SUBJECT: NuScale Power, LLC Supplemental Response to NRC Request for Additional Information No. 132 (eRAI No. 8971) on the NuScale Design Certification Application

Response to Request for Additional Information Docket No. 52-048

eRAI No.: 8971

NRC Question No.: 03.08.04-13

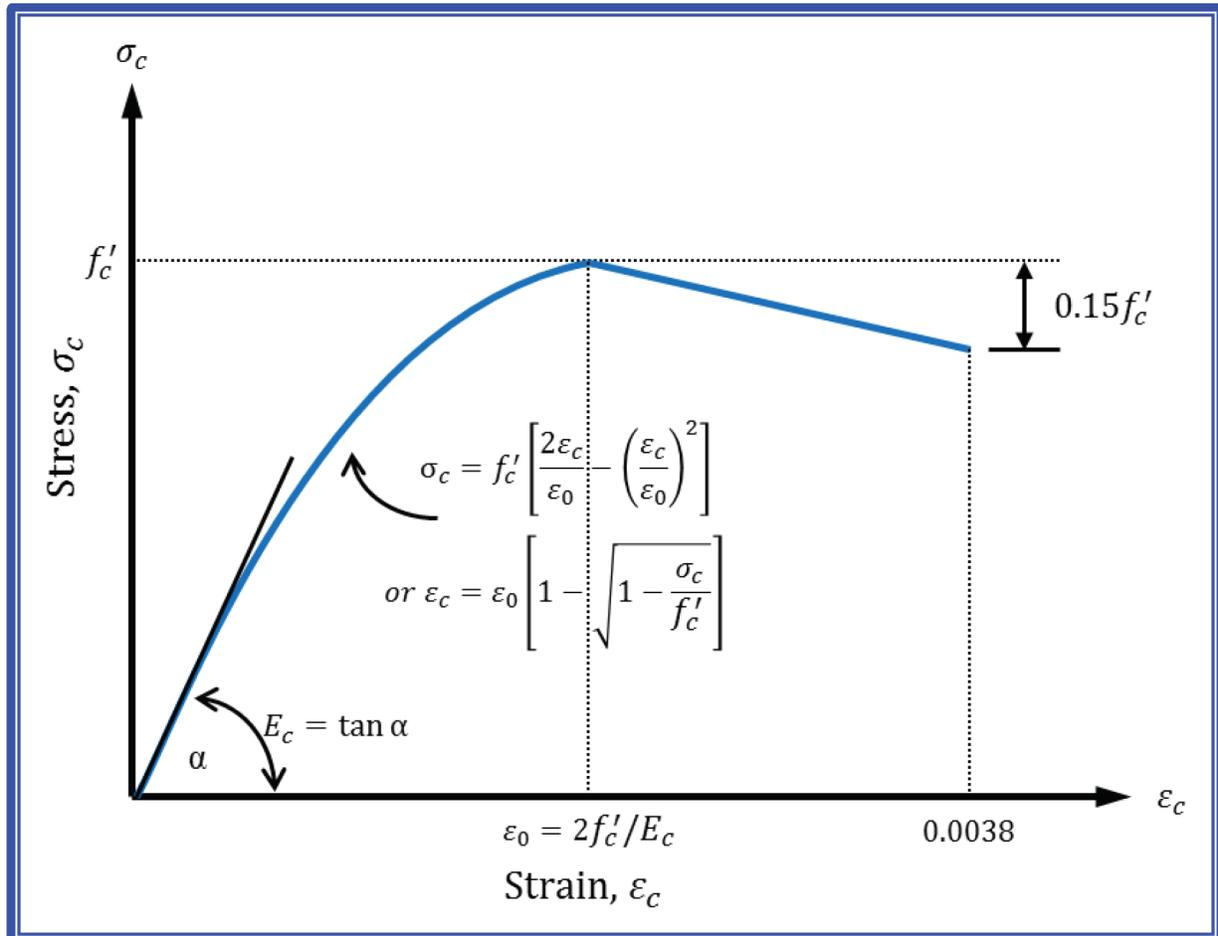
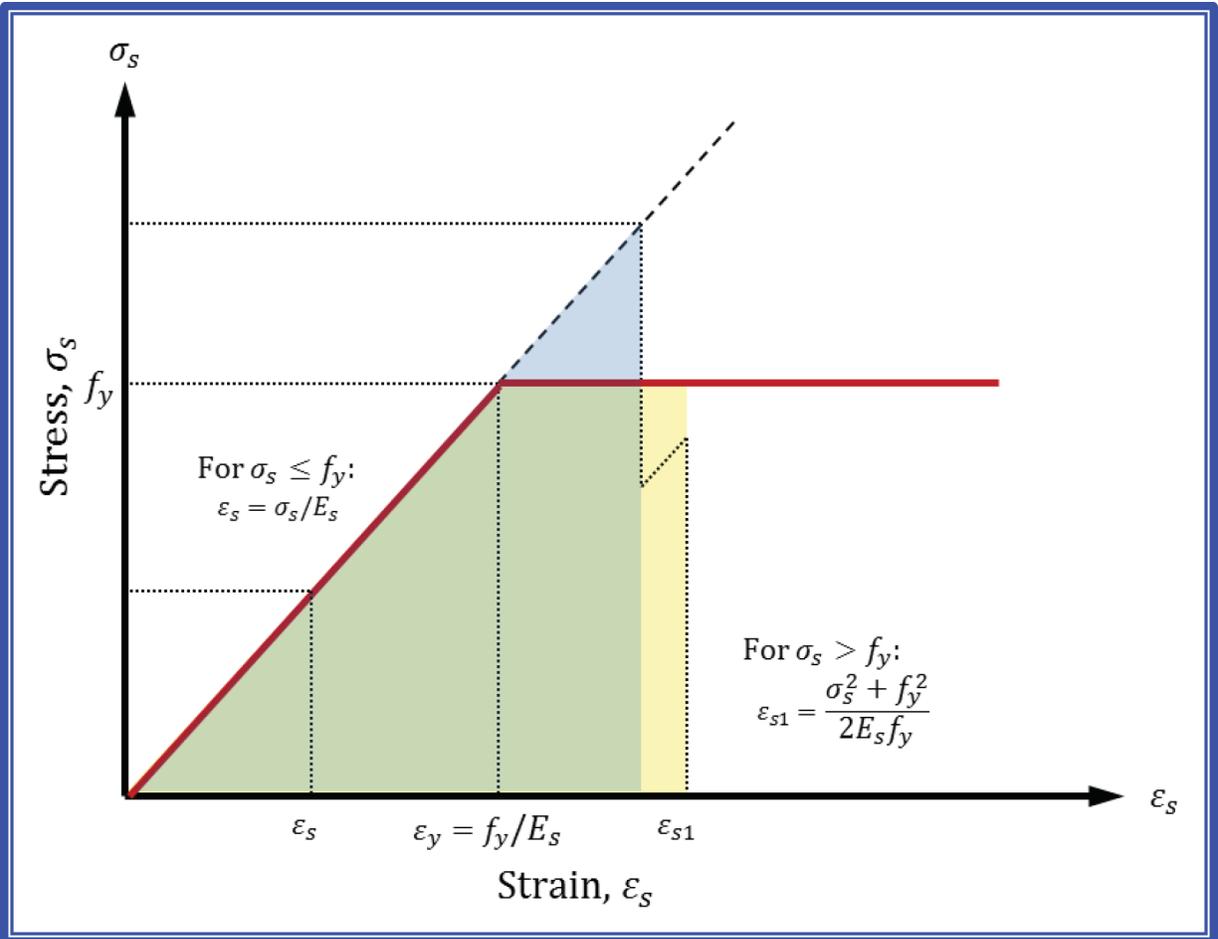
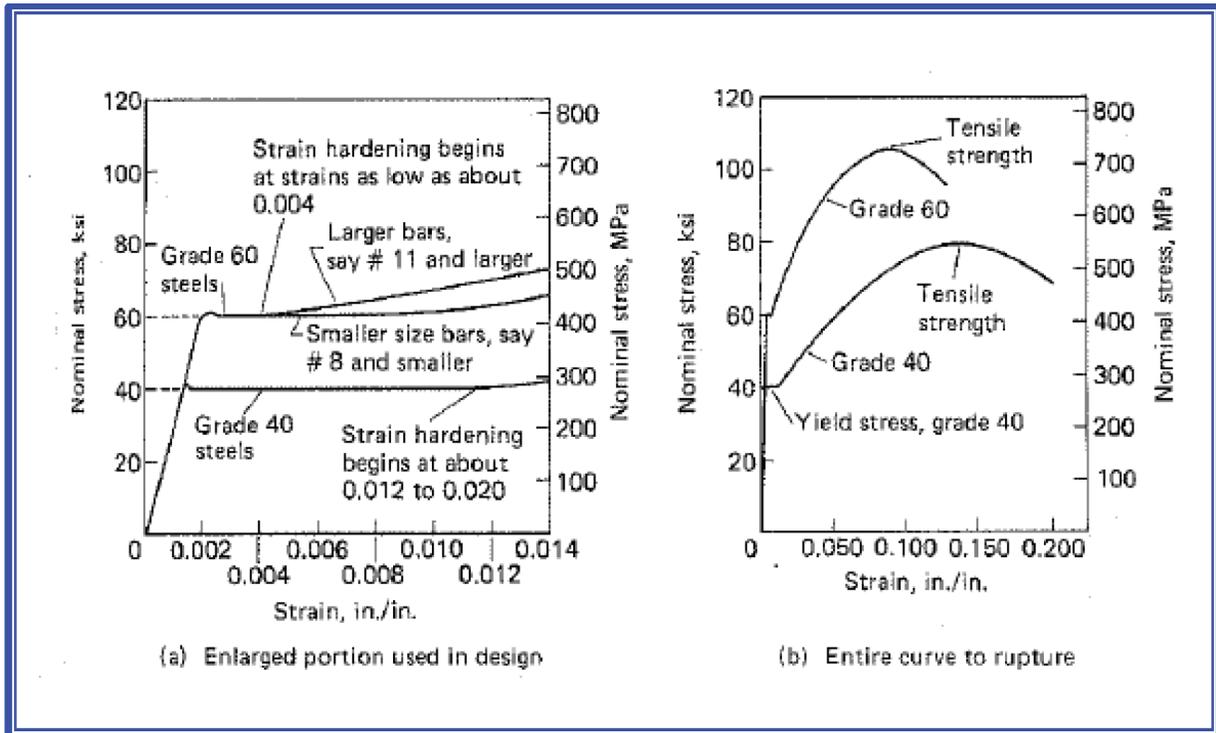
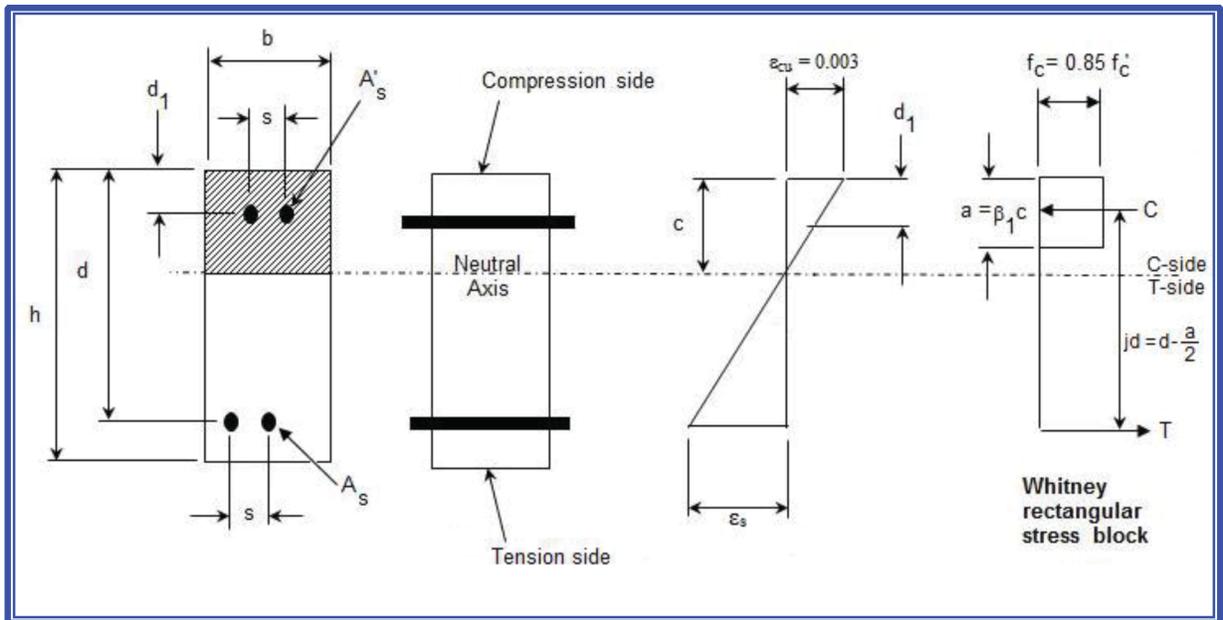
1. The RAI response is missing Figures 3-1 to 3-4, referenced in Sections 3.1 and 3.2 of the response.

AGREE: Figures 3-1 to 3-4 have been added to the respons, as shown below.

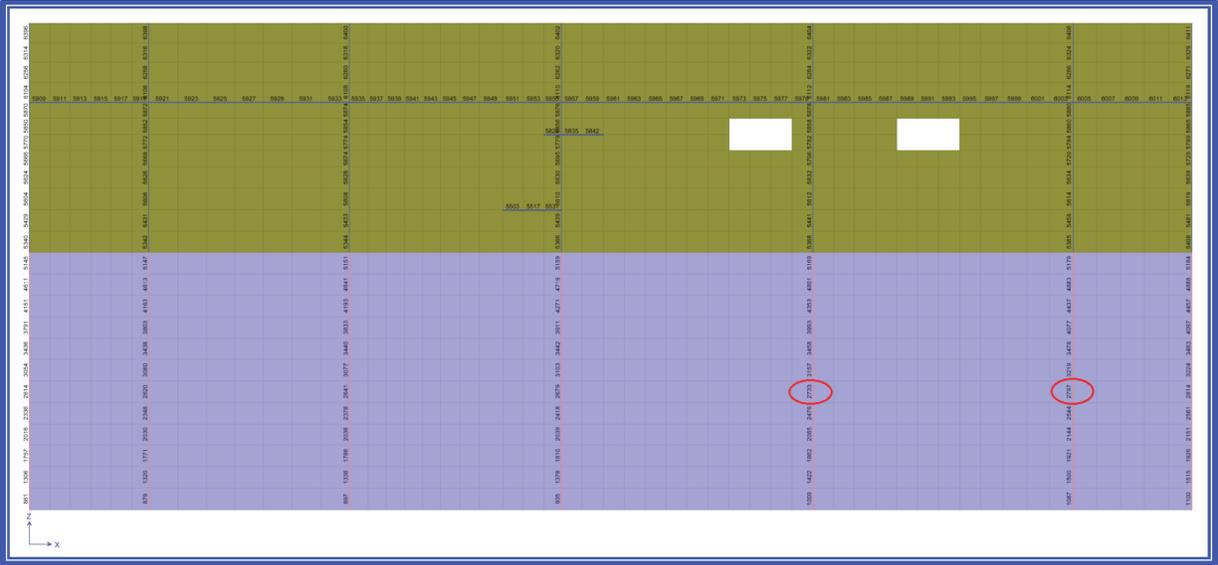
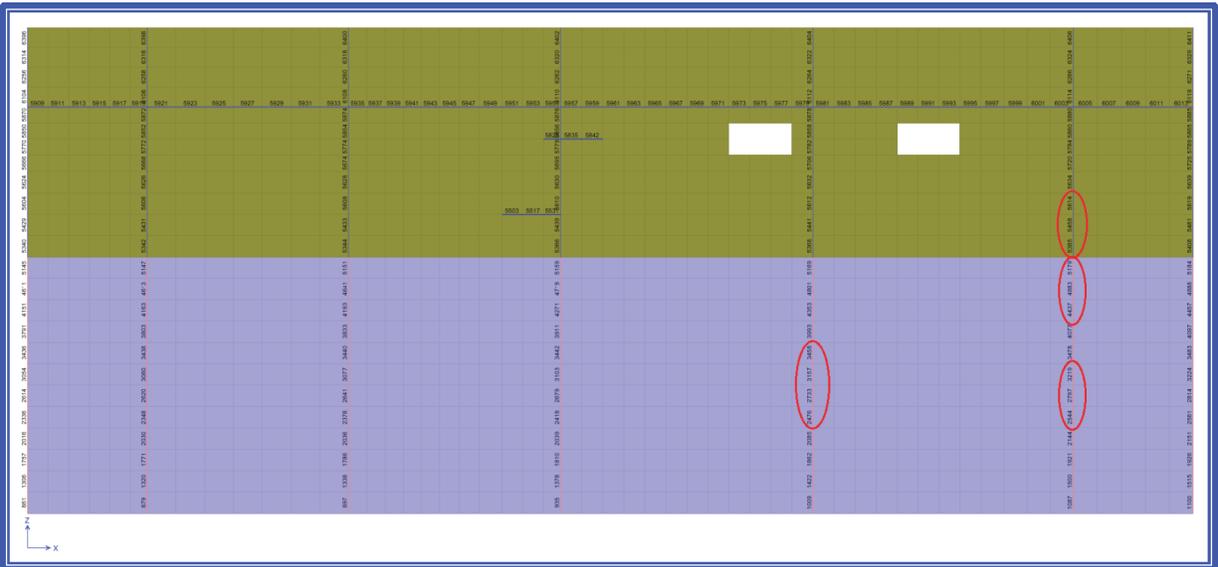
6. Staff Feedback - Please provide justification for the LC 9-9 related ϵ_s result presented in Table 3-14.

Response - As shown previously in Table 3-14 of the response for the pilasters at grid line A, the total strain in the steel exceeds $1.2\epsilon_y$ for load combination 9-9. Therefore, averaging of elements is necessary. Since the strain from T_a+P_a is 0.672×10^{-3} , the remaining allowed strain from SDH is 1.811×10^{-3} . Every element must be checked to see that it is within this allowed strain, and if it exceeds this value, it must be averaged. From the group of elements, frame element 2733 had the highest strain. The averaging for this element is performed below in

Since the averaged ε_{s1} for Element 2733 is 2.078×10⁻³, adding this to the strain from Ta+Pa (0.672×10⁻³) gives a total strain of 2.750×10⁻³, which is greater than 1.2ε_y. However, inspecting the location of the Ta+Pa strain distribution at the location of frame element 2733, which is near the bottom middle of the 5th pilaster counting from east to west (see Fig 3-10 for visualization), a Ta+Pa strain of 0.265×10⁻³ is used.. Therefore, adding the averaged ε_{s1} to this updated Ta+Pa strain gives a total strain of 2.343×10⁻³, which is less than 1.2ε_y (2.483 ×10⁻³) and therefore is considered acceptable.
